**RE: Wilshire Place Subdivision
Conceptual Grading and Drainage Plan
Engineer's Stamp Date: 08/10/18
Hydrology File: C18D103**

Based upon the information provided in your resubmittal received 08/14/2018, the Conceptual Grading and Drainage Plan is approved for Preliminary Plat and Site Plan for Building Permit. This letter replaces the letter written on 8/17/2018.

WILSHIRE PLACE
SITE DEVELOPMENT PLAN
Albuquerque, New Mexico

Sheet Title	Sheet Number
DRAINAGE AND CONCEPTUAL GRADING PLAN	SP2
Date	
AUGUST 10, 2018	
Project No.

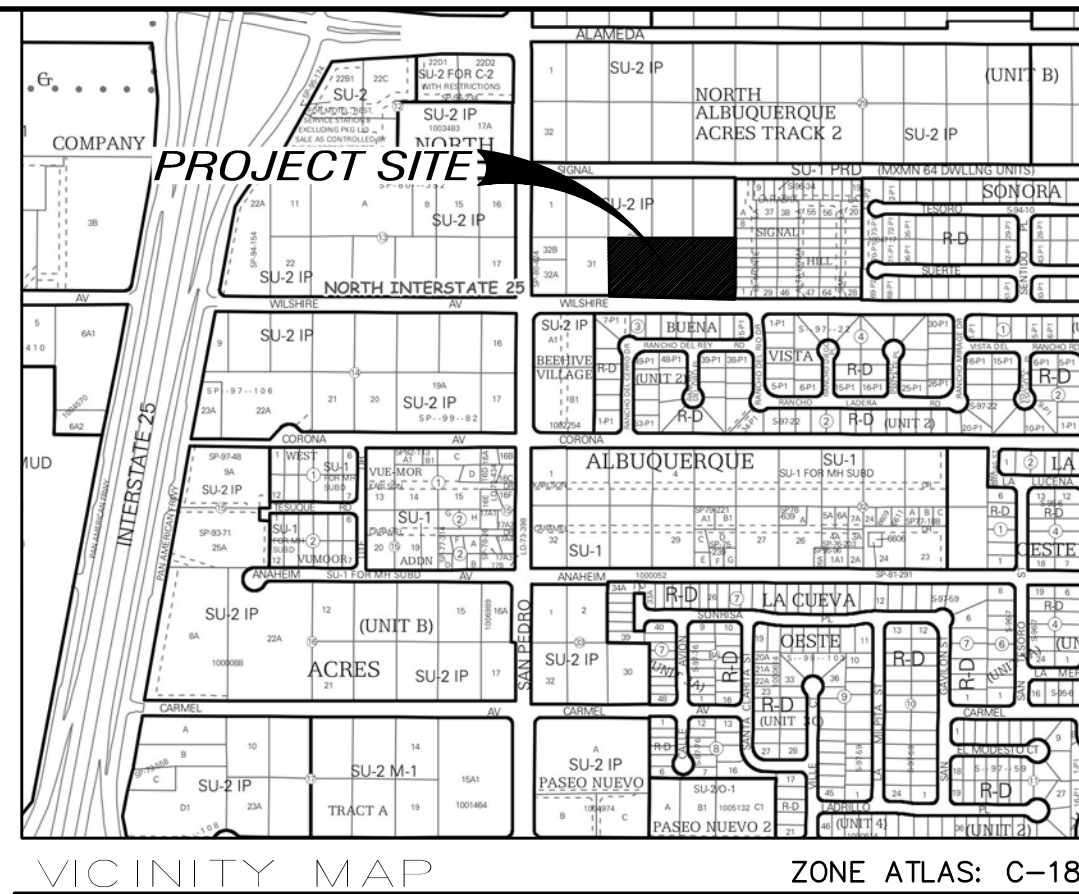
1. Clearly identify all retaining walls on the G&D Plan with a symbol in the legend and on the plan view. Differentiate between walls required by the developer (>2') and walls to be differed to home builders (<2').
2. Show a typical lot grading detail or swales on the individual lots. Include typical sections through the swales at the front of the pads, including both with and without side yard retaining wall.
3. Resolve overlapping text particularly on the pad elevations.
4. Provide hydrology and hydraulic calculations for the detention pond.
5. Provide typical sections of the streets, flow depth calculations, and inlet capacity calculations.
6. Verify downstream capacity or provide a temporary onsite retention pond to remain until the downstream capacity is provided by a separate project.
